PLAN OF TEMPORARY BRIDGE,
 ABUTMENTS & BYPASS ROAD
 BRF 010-1(43)
 ROUTE 9
 MARLBORO, VT

Date: 2/23/2014 Project: Marlboro BRF 010-1(43)
 Comments:
 RT. 9 Marlboro, VT
 Post Mounted Signs Spaced 500' up to 1/10 Mile
 Speed Limit Reduction 2/10 Mile per specs
 PLAN 2 OF 2

Date: 2/23/2014 Project: Side Road Work (TA-1)
Comments:
Project Title: Marlboro BRF 010-1(43) (RT. 9 Marlboro, VT)
Plans Design for: Renaud Bros., Inc. 283 Fort Bridgman Road #2, Vernon, VT 05354
Plans Design By: ADA Traffic Control 888-800-4232
PHASE 1

Date: 2/23/2014 Project: Road Closure with a Diversion (TA-7)
 Comments:
 Project Title: Marlboro BRF 010-1(43) (RT. 9 Marlboro, VT)
 Plans Design for: Renaud Bros., Inc. 283 Fort Bridgman Road #2, Vernon, VT 05354
 Plans Design By: ADA Traffic Control 888-800-4232
 PHASE 2

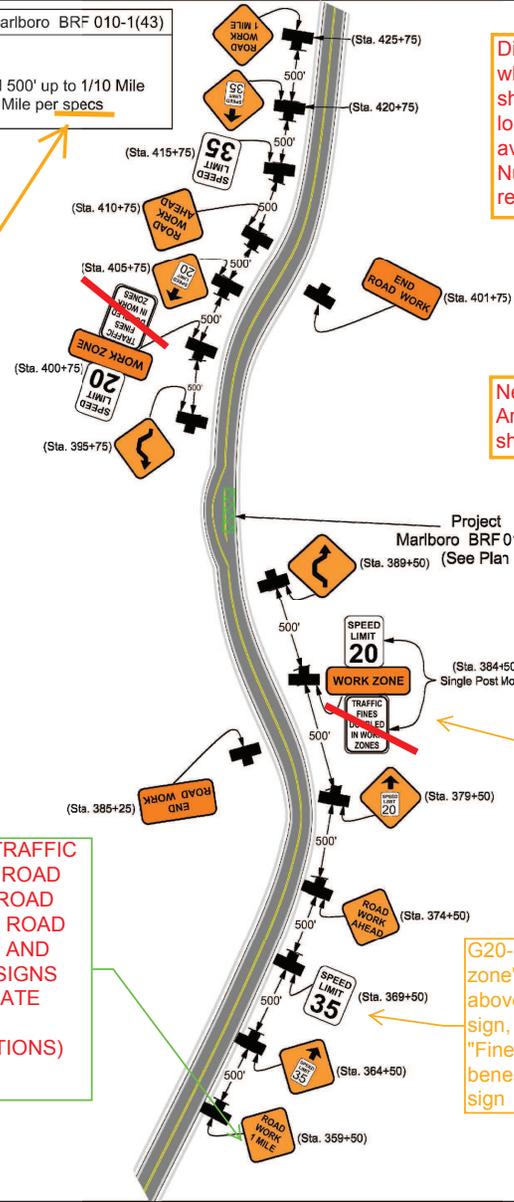
What specs?

Difficult to figure out where this is as shown. Any additional location references available? (Bridge Number / Mile Point reference, etc.)

Something to consider. Instead of two 15-mph regulatory speed reductions (50 to 35 to 20 mph) for the workzone, do two 10-mph regulatory reductions (50 to 40 to 30) and advise the curves leading onto the temporary bridge at 20-mph (or whatever speed warranted, if lower than 30mph). The advisory speed plaque would be installed under the last reverse curves warning sign. If possible, spread out the distance of the two speed reductions a little to give the driver a chance to acclimate to the changes. Say 1500 feet minimum between the regulatory 40 and 30 zones....

Need a North Arrow on all sheets (TYP)

Plan 1 not attached? Is it Sheet 1?

G20-5aP mounted above, omit "fines double"

G20-5aP "Work zone" mounted above speed limit sign, and R2-6aP "Fines Double" beneath speed limit sign

DUE TO THE TRAFFIC VOLUME AND ROAD CONDITIONS ROAD WORK 1 MILE, ROAD WORK AHEAD AND SPEED LIMIT SIGNS SHOULD BE GATE POSTED (BOTH DIRECTIONS)

Marlboro BRF 010-1(43)
PHASE 1

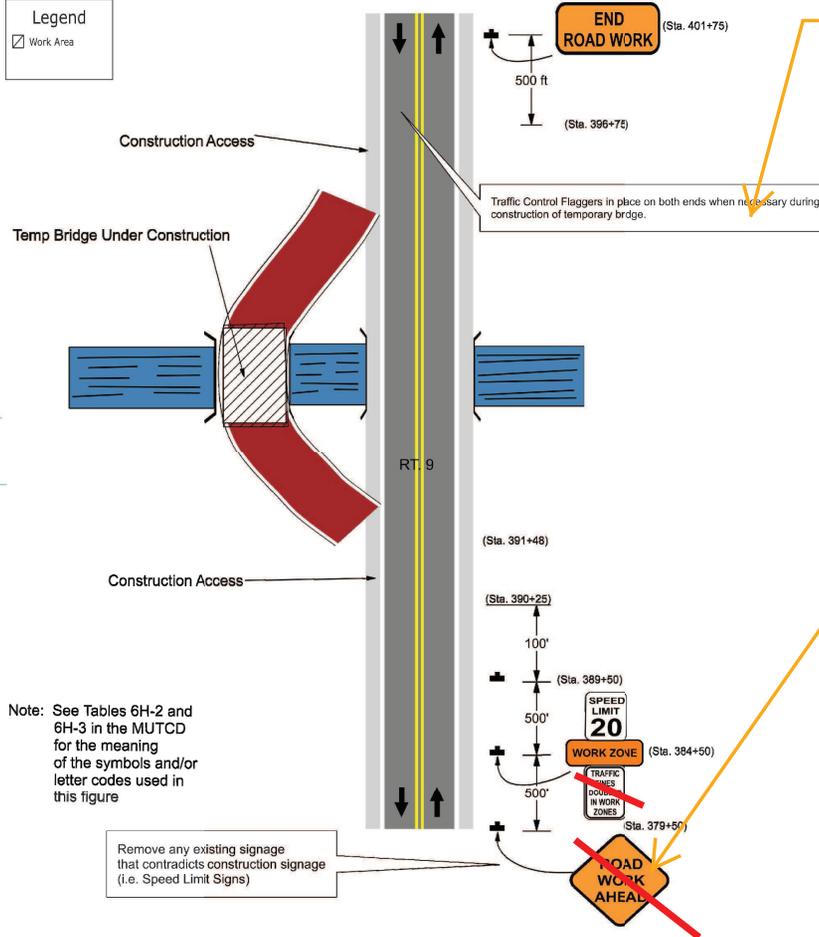
This will obviously require additional advance temporary warning signage.

SHOW PLACEMENT OF FLAGGERS, FLAGGER AHEAD SIGNS, ETC AND HOW THEY INTERACT WITH THE PROPOSED CONSTRUCTION SIGNAGE.

How does this fit in with what is shown on Plan 2 of 2? This sign is shown in the position of the W3-5 20-mph warning sign; why install another RWA if preceded by an existing RWA sign package?

SHOW ANY EXISTING SIGNS THAT CONFLICT WITH CONSTRUCTION SIGNS. FOR EXAMPLE THE 50 MPH SIGN AT STA 392+15 +/- SHOULD BE COVERED
